3M™ DBI-SALA COUNTERWEIGHT SYSTEMS (OSHA & CE)**PRODUCT RETROFIT NOTICE**

Counterweight System & center section Retrofit Part

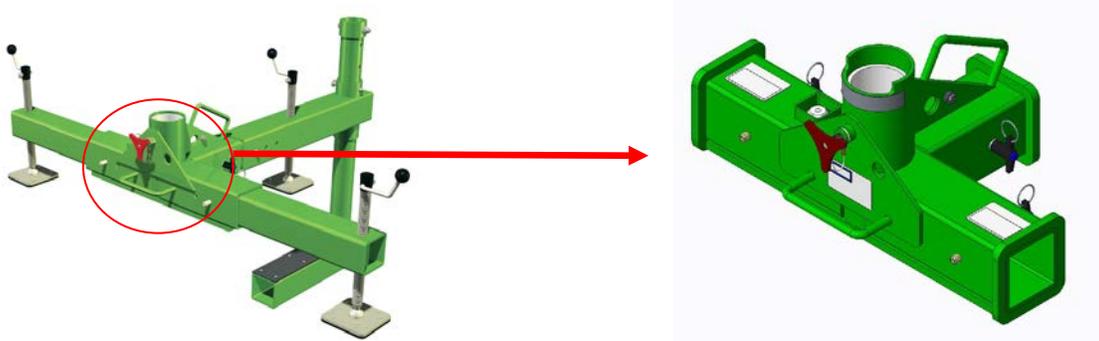
3M Fall Protection has determined that certain Counterweight Systems do not fully meet all load claims in all adjustment positions as represented in the “Instruction for Use” (IFU) manual and on product labels. There have been no reported accidents or injuries associated with this issue. This issue only affects the following systems: OSHA P/N’s 8300010, 8511892, 8512894, 8514496, 8520775, 8530088, 8530146, 8530226 8530256, 8530355 & CE P/N’s 8562894, 8564496. **Note, this is not a product recall.**

To address the issue, 3M Fall Protection has developed a design modification to one component common in all Counterweight Systems (center section P/N 8513593 OSHA or 8541688 CE). The modification has been incorporated in all Counterweight Systems manufactured after March 1, 2017, and will be available as a retrofit at no cost to all end users who purchased their systems prior to March 1, 2017.

End-users: Please contact Customer Service at 800-328-6146 (prompt #2012) or email 3MUSFPServiceAction@mmm.com to receive your Retrofit Kit free of charge. Retrofit Kits P/N’s are 8549057 OSHA and 8549058 CE. If you provide us with your contact information, shipping address, and model details of the system you have, we will send you the Retrofit Kit free of charge. When you receive the Retrofit, please follow the instructions for returning your affected center sections using the pre-paid mailing box. Updated IFUs can be found at <http://capitalsafety.webdamdb.com/#folder/2643471>. Please locate the appropriate IFU for your system.
